Request for Additional Information

SAJ-2023-00198

Please see the comments below requesting additional information to assist in the processing of the Approved Jurisdictional Determination associated with the parcels at Punta la Bandera in Luquillo, PR (SAJ-2023-00198).

Figure A: Lidar Data

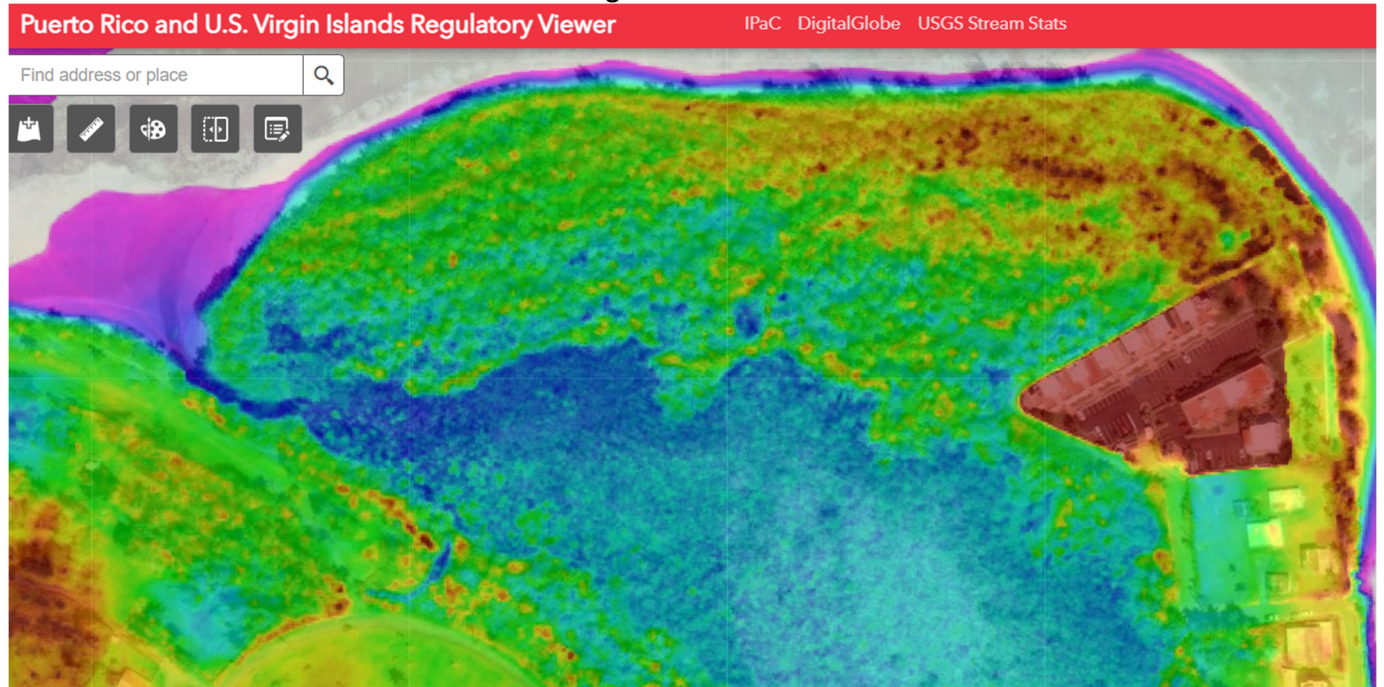
a. Lidar data obtained by the Corps (see Figure A below) indicates that there is a direct surface water connection from the Atlantic Ocean (a Section 10 Water) to the north of the review area into the wetlands delineated in the report provided. The report also noted this tidal connection between the Atlantic Ocean and wetlands in the review area is known as Mata de Platano Creek. It is unclear from the delineation map provided (see Figure B below) whether portions of Mata de Platano Creek are included within the review area for the Approved Jurisdictional Determination, and where the potential boundary between Section 10 Waters and Section 404 Waters is located. Therefore, please provide the following:

- i. Map or graphic clearly depicting the location of the review area for the AJD and surrounding tidal waters, including the MHWL limits of the Atlantic Ocean and Mata de Platano Creek in relation to the wetland area. This graphic should clearly illustrate whether Mata de Platano Creek is in the review area for the AJD.
- ii. Please provide a graphic of the OHWM and the MHWL for the tidally influenced Mata de Platano Creek.
- iii. Please confirm whether Mata de Platano Creek is a relatively permanent water or a non-relatively permanent water.
